CEFCO SPRINGHILL MOBILE SUBDIVISION

APPLICATION NUMBER 6 DATE January 7, 2016

REQUEST Subdivision

DETAIL SITE PLAN

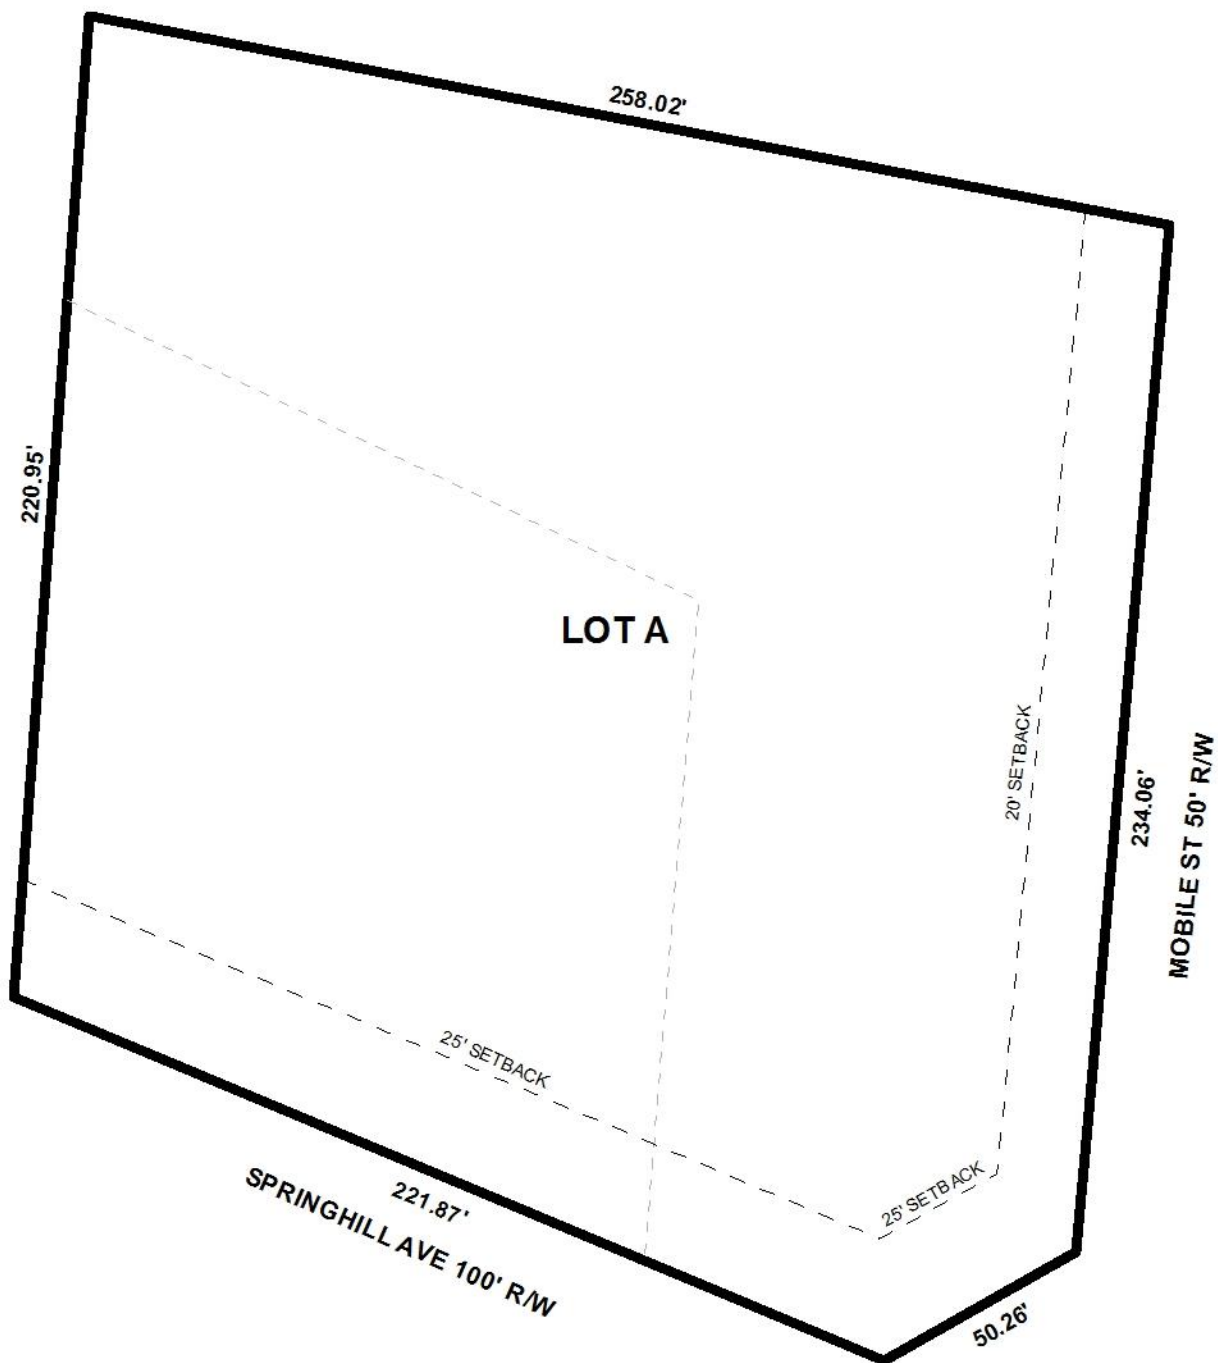
The proposed lot fronts both Springhill Avenue and Mobile Street. Springhill Avenue, a planned major street as shown on the Major Street Plan Component of the Comprehensive Plan, requires a 100' right-of-way width. Mobile Street is a proposed major street with curb and gutter that requires a right-of-way width of 80': dedication was not required in 2008 due to the impact it would have on an existing structure. As complete redevelopment of the site is proposed, dedication to provide 40' from the centerline along Mobile Street should now be required. No additional right-of-way will be required along Springhill Avenue.

Being that the subject site has frontage along both Springhill Avenue and Mobile Street, the applicant must ensure that the property lines at this intersection provide a compliant curb radius. The Final Plat, if approved, should be revised to illustrate a dimensioned curb radius in compliance with Section V.D.6. of the Subdivision Regulations.

The Subdivision Regulations require a minimum distance of 25' setback from the front property line to all buildings on site. The plat depicts a minimum setback line distance of 25' along

Springhill Avenue; however only a minimum setback line distance of 20' is shown along Mobile Street, which is allowed by the Zoning Ordinance.

Because the proposed Subdivision will result in a lot with multiple structures, the applicant should either submit a Planned Unit Development application, or demolish some of the existing structures so only one remains.

Springhill Avenue is an ALDOT managed facility. As a means of access management, a note should be placed on the Final Plat stating that the proposed lot is limited to one curb cut to Springhill Avenue and one curb cut to Mobile Street, with the size, location and design to be approved by Traffic Engineering and conform to AASHTO standards.

The preliminary plat does not depict the proposed lot size in square feet or in acres as required by Section V.D.2. of the Subdivision Regulations. This information should be indicated on the Final Plat, if approved.

- 1) Dedication to provide 40' from the centerline of Mobile Street;
- 2) Illustration of the 25' minimum building setback line along Springhill Avenue;

- 3) Revision of the 20' minimum building setback line along Mobile Street to reflect dedication;
- 4) Revision of the plat to provide a dimensioned curb radius in compliance with Section V.D.6. of the Subdivision Regulations.

- 5) Placement of a note on the Final Plat stating that the lot is limited to one curb cut to both Springhill Avenue and Mobile Street, with the size, location and design to be approved by Traffic Engineering and ALDOT, and conform to AASHTO standards;

- 6) Revision of the Final Plat to depict the lot size in square feet and in acres;
- 7) Compliance with Engineering comments (*The following comments should be addressed prior to submitting the FINAL PLAT for acceptance and signature by the City Engineer:*

- 11) *Either submittal of a Planned Unit Development application, or obtain demolition permits for all but one structure prior to signing the Final Plat.*
